Server Update

For eRAD RIS
Version 2.0
Build 42
Update 42.0.5

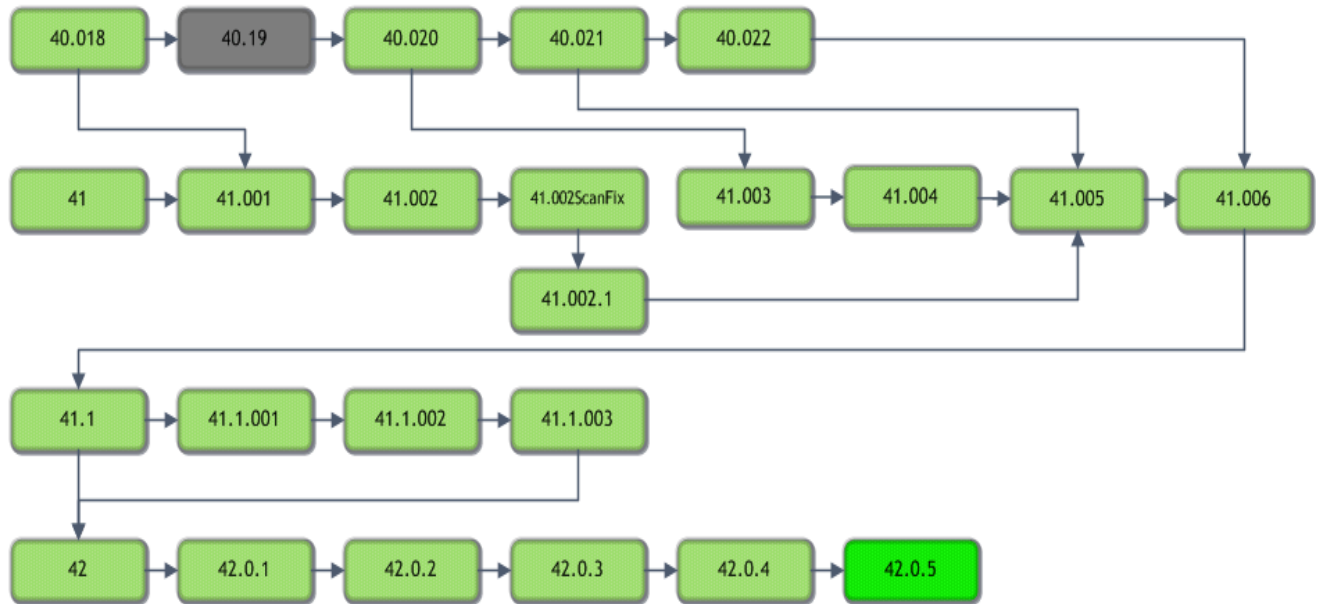
A configuration change to the ris.exe.config file was introduced in build 2.42 this setting was designed to lessen the delays when retrieving lookup tables that are larger in size. This config setting, as mentioned, is located in the ris.exe.config file located in the <appSettings> section of the file

Where the value can be any lookup table, and a value="*", will retrieve all lookups.

The setting has resulted in undesired results of possible slowness, depending on the lookup table, and possibly additional bugs. Because of this, we are requesting that all sites comment out this line in the ris.exe.config table. The commented line will look like

```
<!--<add key="RowLevelCacheDataSetNamesCSV" value="ProcedureCode,TemplateMacro,Indication"/> -->
```
